DESIGN	cp	DRAWN BY	DART AEROSPACE HAWKESBURY, ONTARIO, CAN	
CHECK	(ED	APPROVED	DRAWING NO.	REV. A
	#	4	DSI 9203	SHEET 1 OF 1
DATE		1	TITLE	SCALE
01.04.25			350/355 CARGO MIRROR	NTS
Α		01.04.25	NEW ISSUE

DART SERVICE INSTRUCTION

TO AMEND INSTALLATION DRAWING D350-561 REV. B CANADIAN STA: SH91-20 US FAA STC: SH856NE

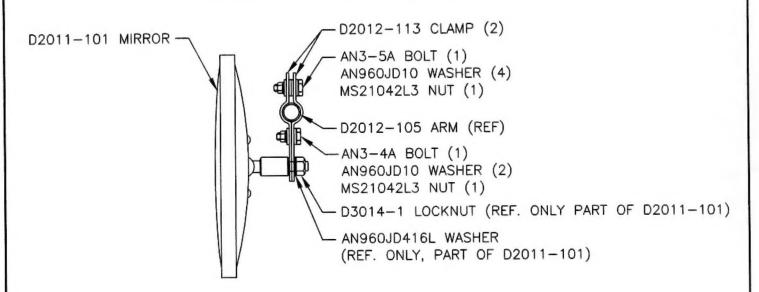
THE PARTS LIST OF D350-561 REV. B SHOULD BE AMENDED AS FOLLOWS:

REMOVE:

QTY				
-045	-043	-041	Part Number	Description
1			AN3-5A	BOLT
2			AN960PD10	WASHER (OR AN960-10 OR AN960JD10)
3		1	AN960PD416	WASHER (OR AN960-416 OR AN960JD416)
1		1	MS21083N4	NUT (OR MS21042-4/L4)

ADD:

QTY					,,,,,
-045	-043	-041	Part Number	Description	
1			AN3-4A	BOLT	
1		1	AN960JD416L	WASHER (REF)	
1		1	D3014-1	LOCKNUT (REF)

THE D350-561-045 MIRROR KIT SHOULD BE INSTALLED ON THE D2012-105 ARM AS SHOWN BELOW WHEN INSTALLING A D350-561-043 DUAL MIRROR ASSEMBLY.
